24th May, 2021

Application No: 3/2021/0388 – 6 Downham Road, Chatburn BB7 4AU

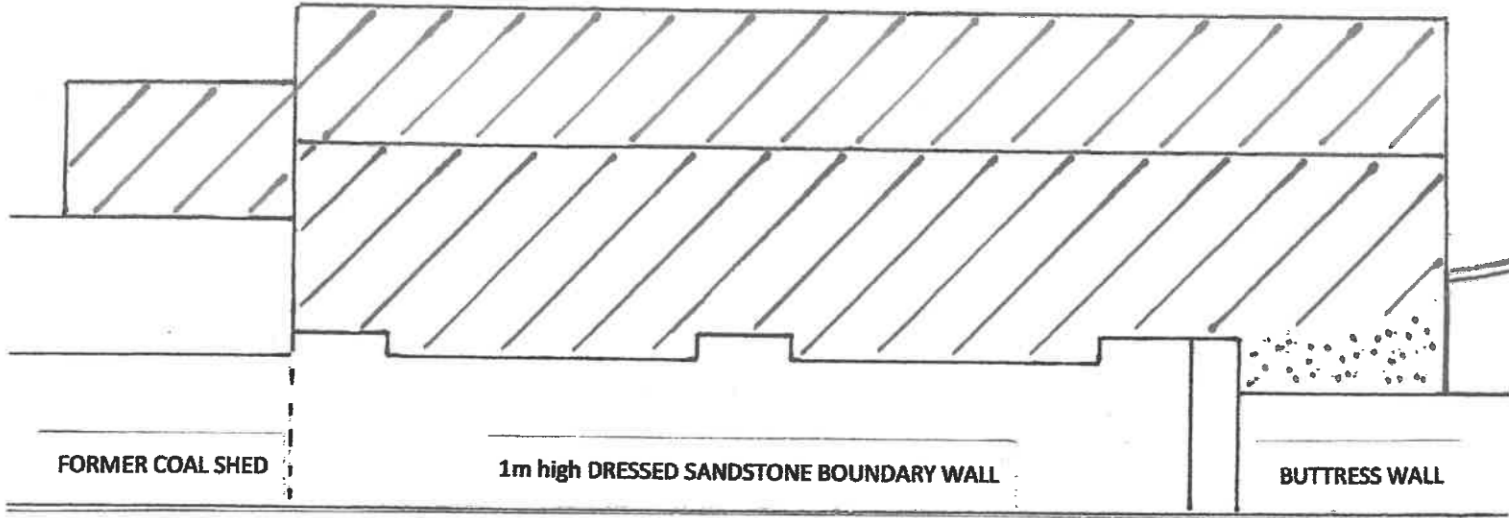
To reiterate, the approved plan shows the outline of a 3.145m high wall bordering [REDACTED] and 6 Downham Road. THIS IS NOT A BOUNDARY WALL. It is literally the rear wall of the modern outbuilding keyed in to the roof terrace and all other walls of the outbuilding, which have to be dismantled together to avoid a potential crisis. The dismantling of the whole modern outbuilding will NOT affect the approved small outbuilding, which will be situated in the same position abutting the former coal shed wall and dressed sandstone boundary wall, belonging to [REDACTED].

I cannot stress more strongly how serious this matter is and must be addressed. With safety in severe jeopardy, can we please ask the Council to enact their duty of care and ensure correct measures are put in place to oversee the dismantling of the whole present modern outbuilding. I would be grateful to hear from you of how and when this will take place. As this incongruous structure continues to deteriorate, hopefully its' removal will be soon.

**PRESENT REAR VIEW OF MODERN OUTBUILDINGS
AS SEEN FROM [REDACTED]**

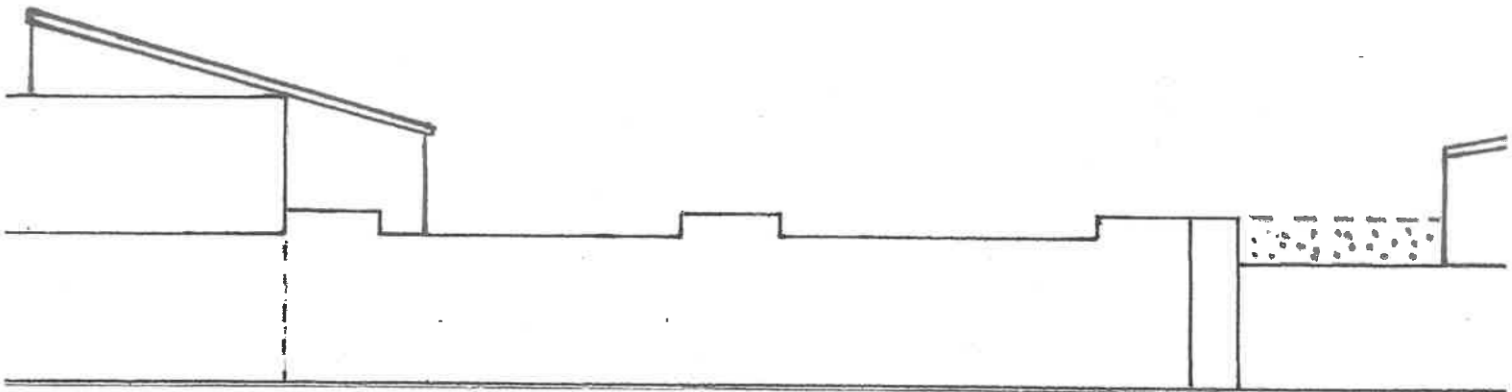
With the potential severe consequences, leaving the rear wall of the modern outbuilding in situ is not an option. It was constructed merely as part of an outbuilding/roof terrace, not a strong, purpose-built boundary wall. To leave this unstable 3.145m high wall as a border between the two small back yards of 6 Dowham Road and [REDACTED] would not only endanger lives, but breaches the statutory height regulation of 2m for boundary walls. It will continue to have a harmful impact upon the setting of the Listed Building, the character and appearance of the Chatburn Conservation Area and a significant and unacceptable impact upon residential amenity, with the severe overbearing of [REDACTED] contrary to Key Statement EN5 and Policies DME4 and DMG1 of the Ribble Valley Core Strategy.

**AFTER REAR OF MODERN OUTBUILDINGS DEMOLISHED
WITH PROPOSED SINGLE STOREY OUTBUILDING**

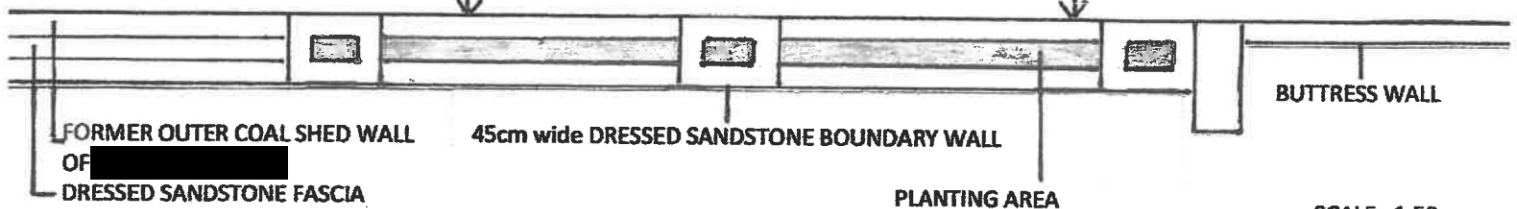
If the owners of 6 Downham Road wish to have a 2m wall abutting the dressed sandstone boundary wall, could I please suggest this be built of natural stone, as 10cm-25cm of wall would be visible above, but independent of, the dressed sandstone boundary wall of [REDACTED]. A cement blockwork wall would not be acceptable within the setting of the Listed Building nor within the Chatburn Conservation Area, where limestone walls are a prominent feature. You have approved the small outbuilding walls to be rendered blockwork which, I feel, may set an unfortunate precedent within the Conservation Area, but please ensure this does not extend to curtilage walls. As I stated in my representation: *"There will be at least 10 square metres of re-usable random natural limestone available once the present high structure is dismantled"*. This would be ideal material for any possible wall construction, but please ensure no wall is built above the statutory height limit of 2m.

BOUNDARY LINE TO BE RESPECTED
